AMENDMENT OF SOLICITATION/MODIFICATION OF CONTRACT			1. CONTRACT ID CODE	PAGE	OF PAGES
2. AMENDMENT/MODIFICATION NO. 0004			3. EFFECTIVE DATE 24 March 2011	4 REQUISITION/PURCHASE REQ NO. N/A	PROJECT NO. (If applicable)

14. DESCRIPTION OF AMENDMENT/MODIFICATION (Organized by UCF section headings, including solicitation/contract subject matter where feasible.)					
DESIGN/BUILD FOR RELOCATION OF SECTOR BUILDING, U. S. COAST GUARD SECTOR HOUSTON-GALVESTON, HOUSTON, TX

AMEND SOLICITATION NO. HSCG47-09-R-3EFK03/X0007 AS FOLLOWS:

PROJECT NUMBER DRAWING NUMBER
08-3101726 A083101726C101
DISCIPLINE/SHT NO SHEET 1 OF 2
C101

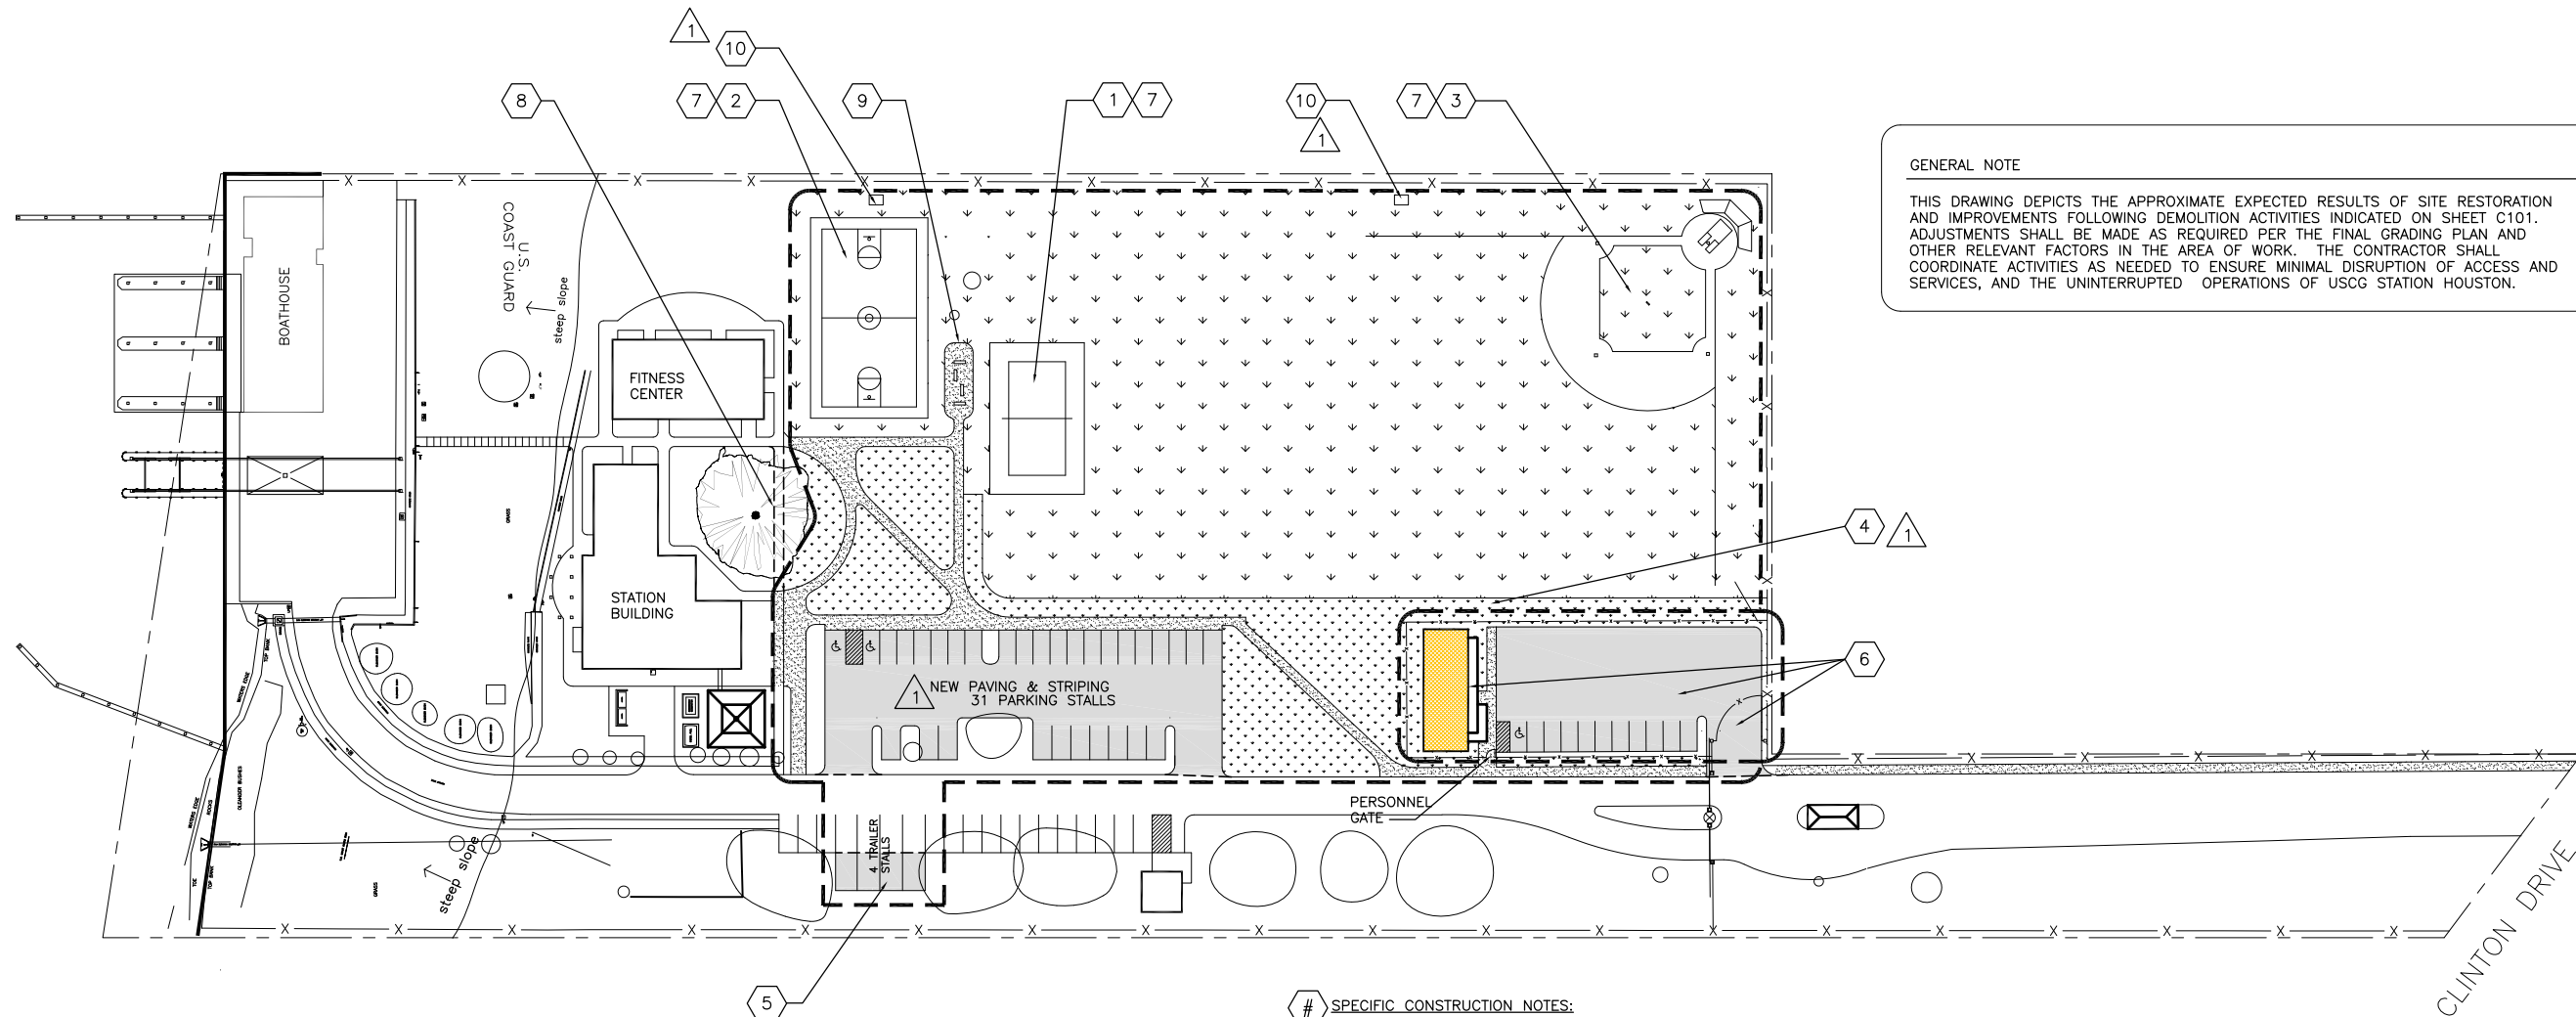
65. Amendment #2, Drawing C101 indicates removal of 4 portable buildings, a storage container and a concrete building. Please provide as-builts of these building and advise where they are to be turned over to the Government or if they are to be disposed of by the Contractor.

66. Amendment #2, Drawing C101 calls for the removal of a temporary basketball court. Drawing C102 calls for a new larger basketball court in the same location. Please advise if the existing goals can be reused for the new court.

Response: No as-builts are available. Contractor shall dispose of all Government owned modular trailers. The modular trailers that are rented shall be removed by the rental company. An Amendment will be issued to identify owned vs. rented trailers. Storage containers and concrete building in the NW corner shall be disposed of per the Phase 2 drawing C101.

Response: No, provide new.
